Access Compliance Report Public Rights-of-Way (Curb Ramps)

Main Street: TRIUMPHAL_WAY Cross Street: SUBURNAS_WAY Location: SW

ADA ID: RPAT211015142703 Ramp Type: Type 1 - Perpendicular Diagonal Initial Pass/Fail: Fail Overall Compliance: No Severity Score: 2

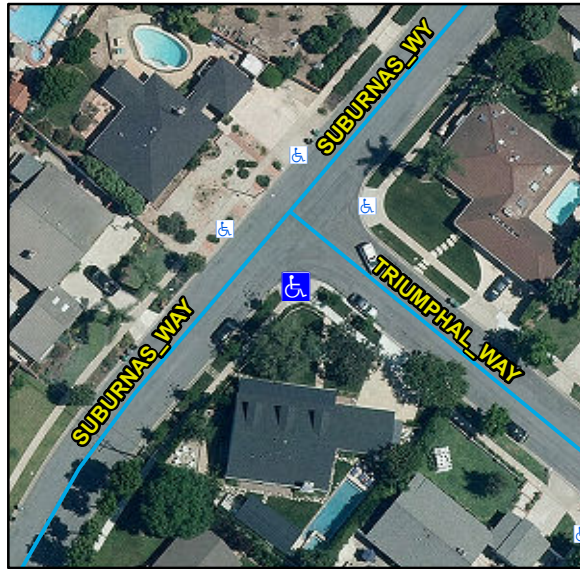
R304.5.3, STD 1115

Remove & Replace Curb Ramp With Two New Directional Ramps or Equivalent.
